# Recall Bulletin

## PRODUCT SAFETY RECALL

**SUBJECT:** Electric Power Steering Assist

**MODELS:** 2009-2010 Chevrolet HHR (Non-Turbo)  
2010 Chevrolet Cobalt  
2004-2007 Saturn ION  
Equipped with Electric Power Steering

### **Power Steering Assist Motor Housing Inspection -- All Vehicles Except Chevrolet HHR**

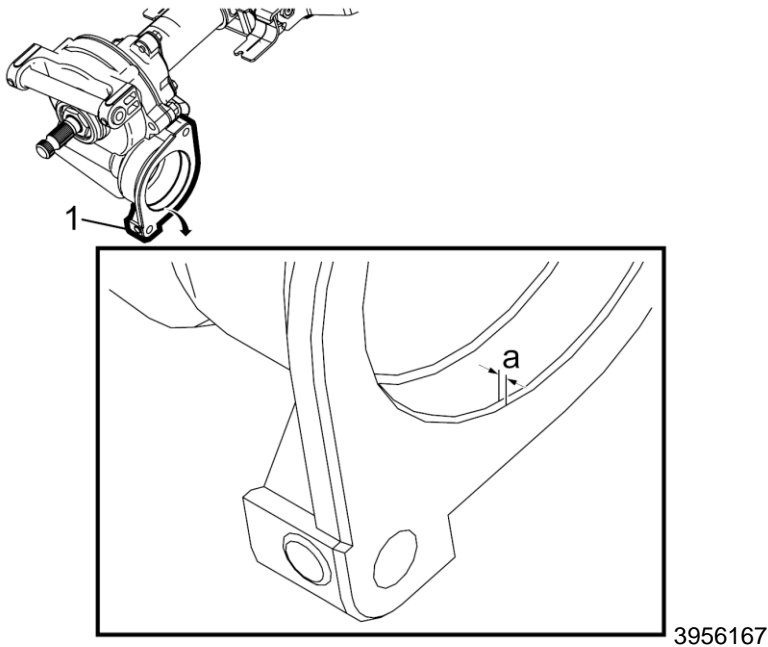
**Caution:** First design steering motor with a small chamfer does not require a seal. If a seal is installed on a first design steering motor, potential damage to the steering motor may occur resulting in loss of assist steering. Seal is only required for the second design steering motor with the larger chamfer. Before installing the power steering assist motor, inspect the power steering assist motor housing (1) to verify the steering column design.

- **First Design:** If the chamfer (a) is **1 mm (0.04 in)** and **30 degrees** then the steering column is the first design and a power steering assist motor O-ring seal is NOT needed.
- **Second Design:** If the chamfer (a) is **2.7 mm (0.11 in)** and **45 degrees** then the steering column is the second design and a NEW power steering assist motor O-ring seal IS needed.

1. Remove the power steering assist motor. Refer to *Power Steering Assist Motor Replacement* in SI.
2. Install the new power steering assist motor. Refer to *Power Steering Assist Motor Replacement* in SI.
